SECTION 00 91 15

ADDENDUM NUMBER 6

- 1.01 DATE: APRIL 6, 2021**
- 1.02 PROJECT: WELCOME CENTER**
- 1.03 PROJECT NUMBER: DCM NO. 2020604**
- 1.04 OWNER: ALABAMA A&M UNIVERSITY**
- 1.05 ARCHITECT: NOLA | VAN PEURSEM ARCHITECTS, PC**

SHEET NUMBER
S-3.1
OF
16

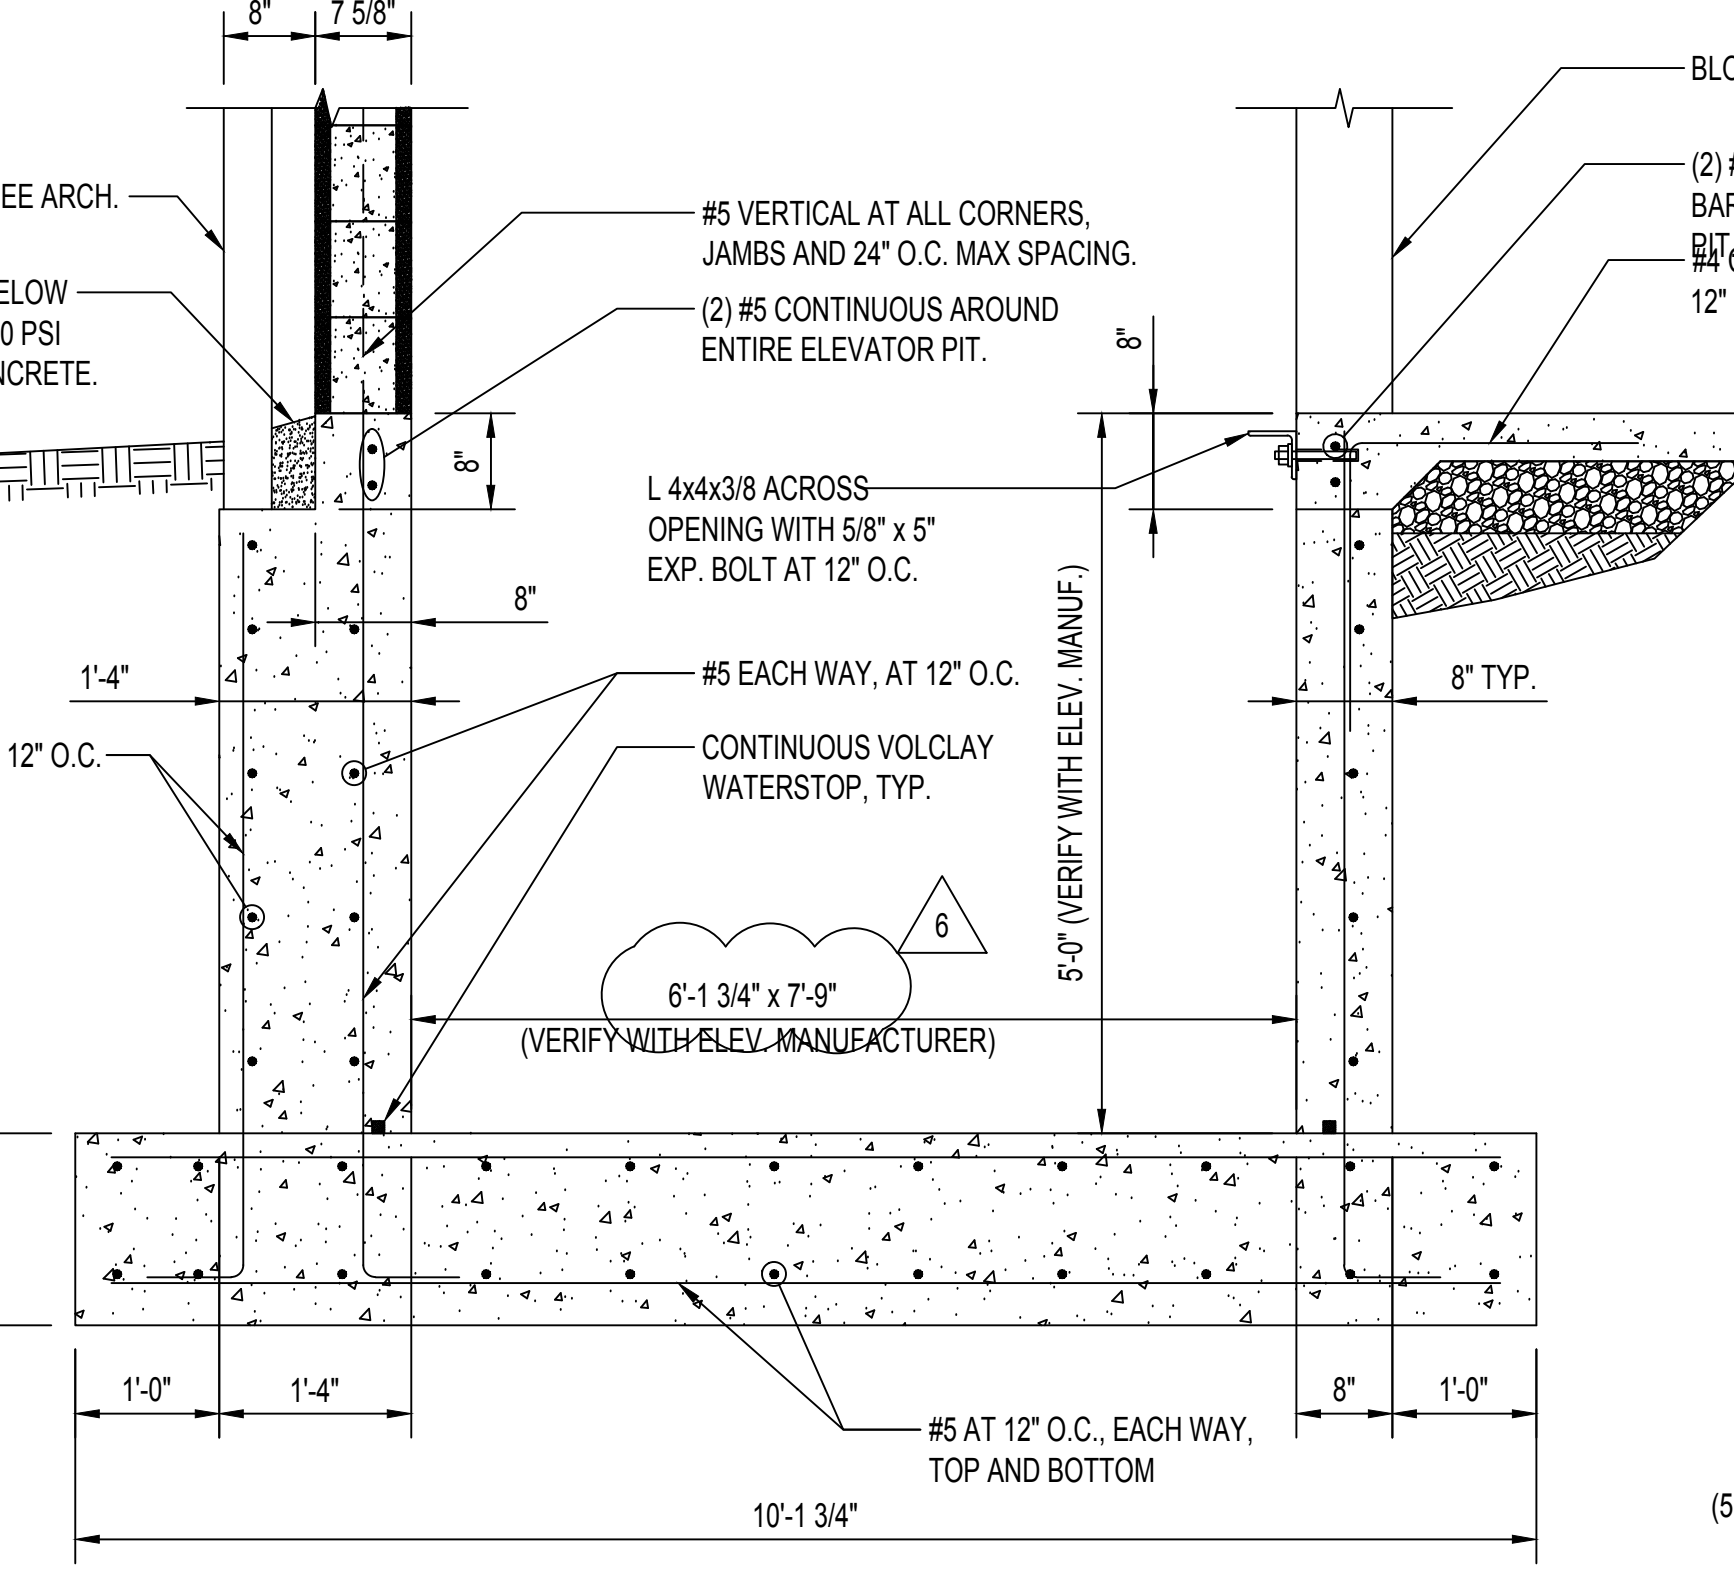
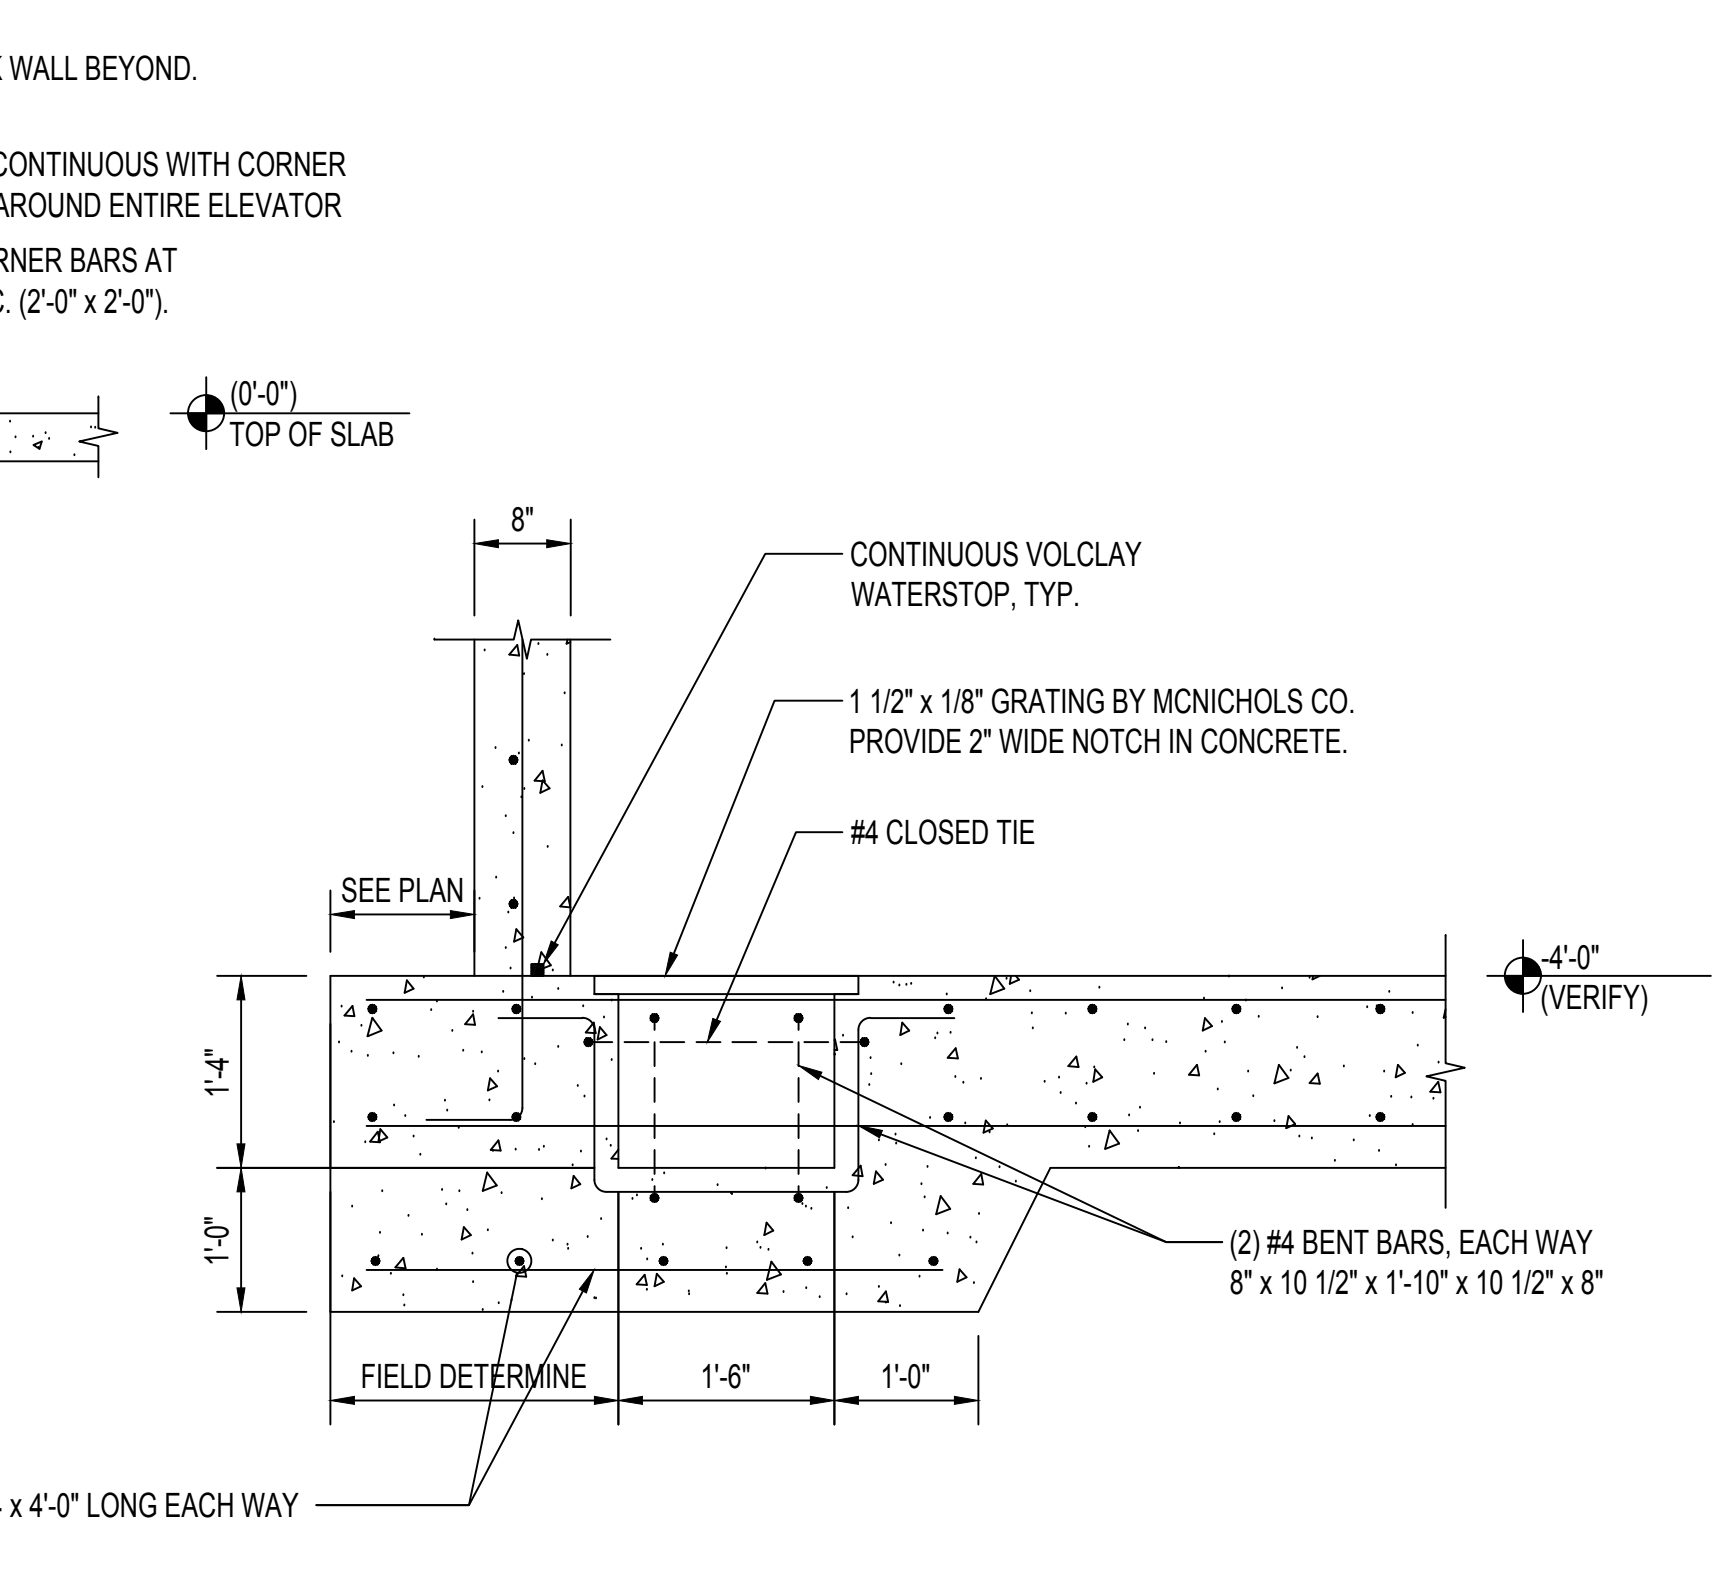
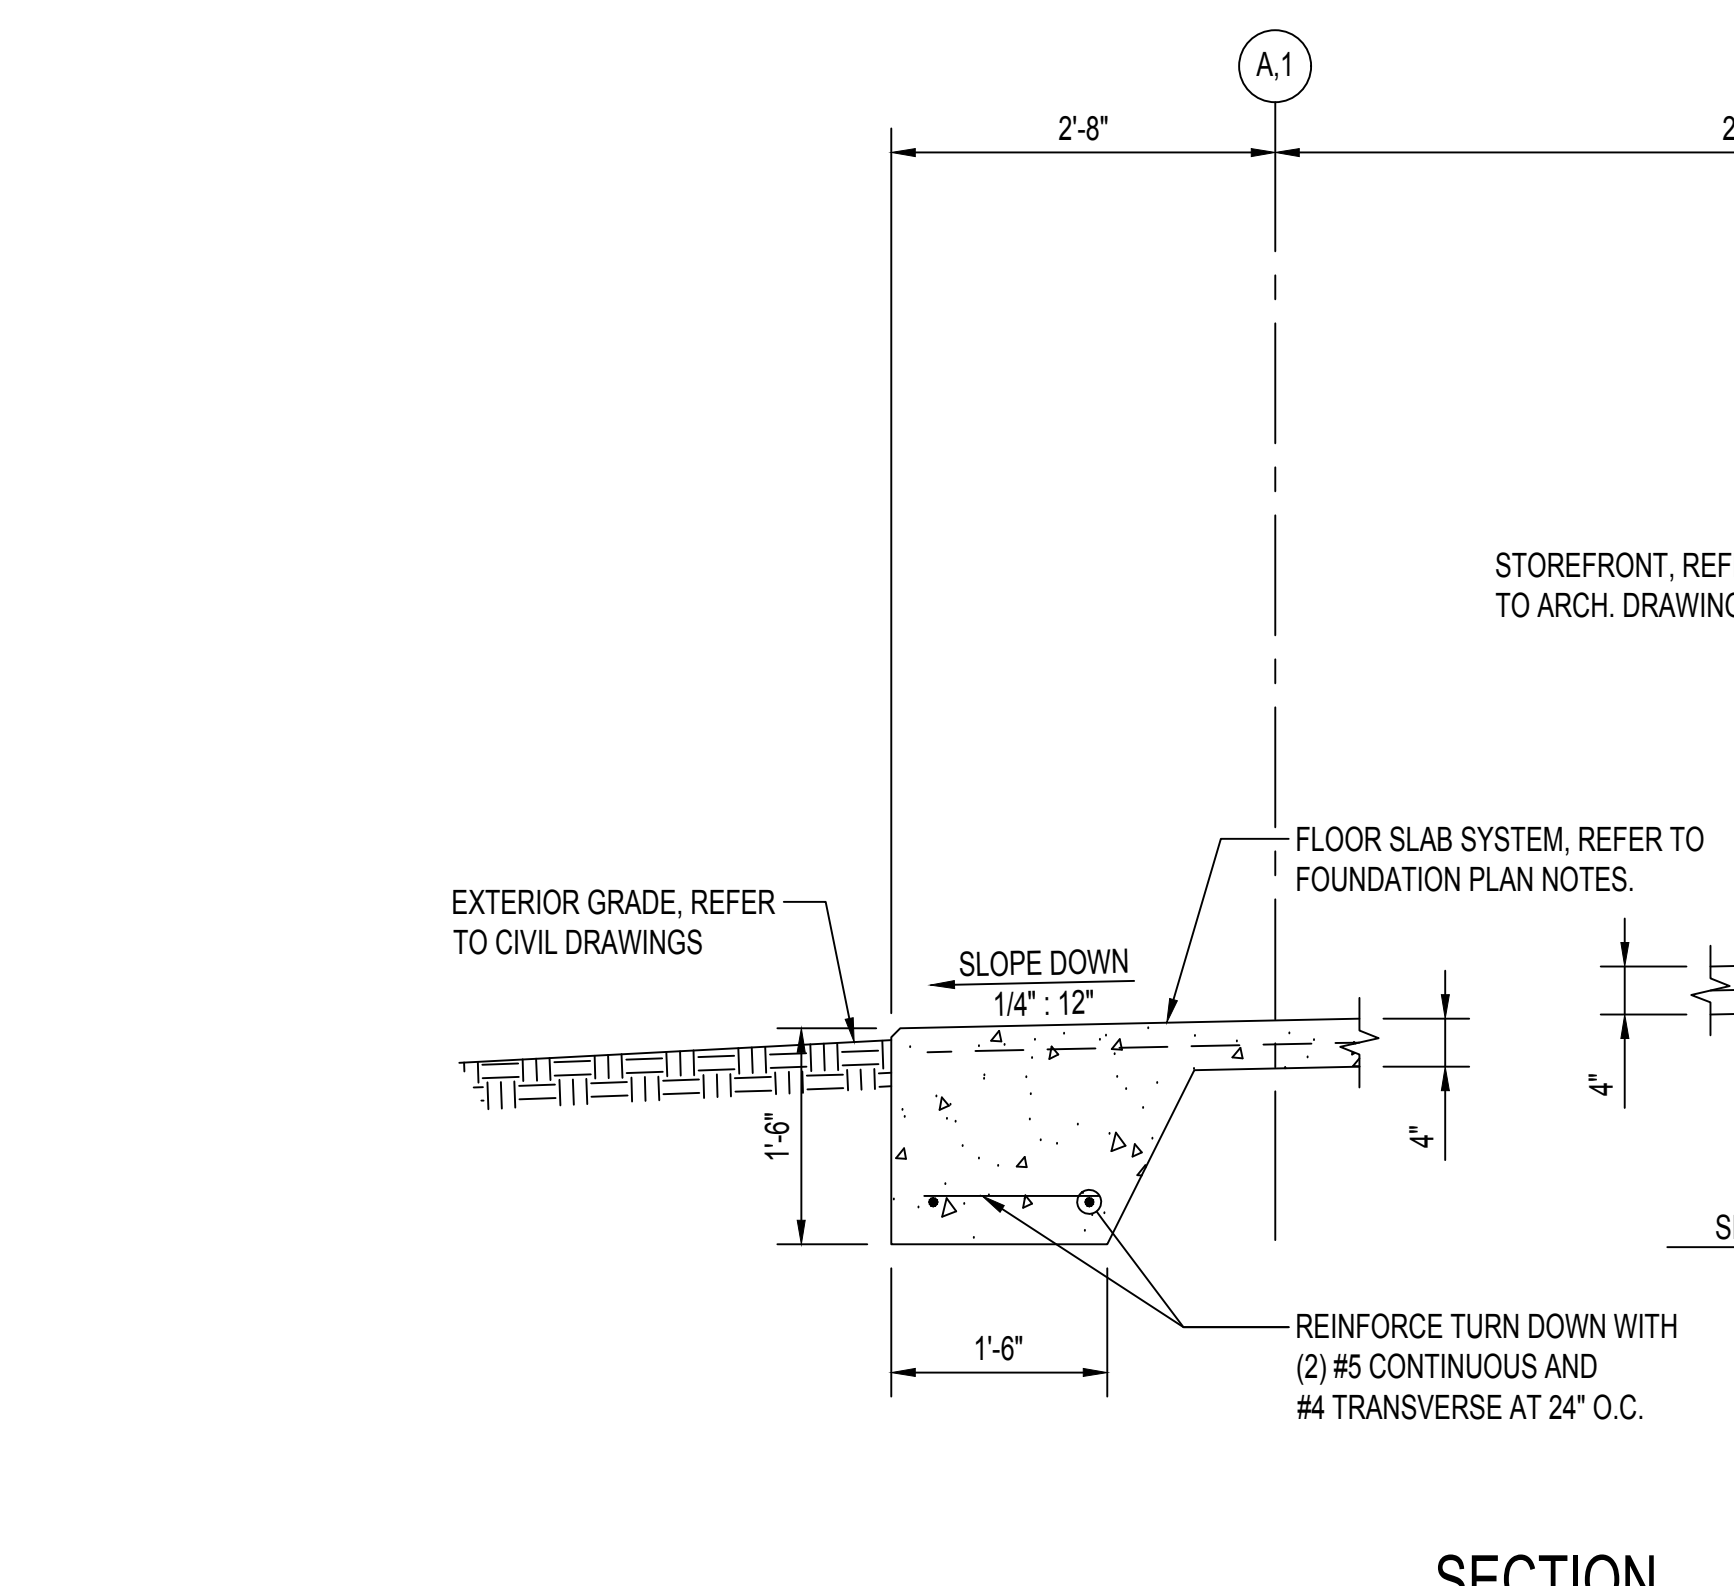
4.23 SHEET S-3.1 – WALL SECTIONS:

- A. Replace this sheet in its entirety. Revisions include the following:
1. Added Sections J/S-3.1 & K/S-3.1.
 2. Revised dimensions on detail F/S-3.1
 3. Added contractor’s option to use beams at Section H/S-3.1
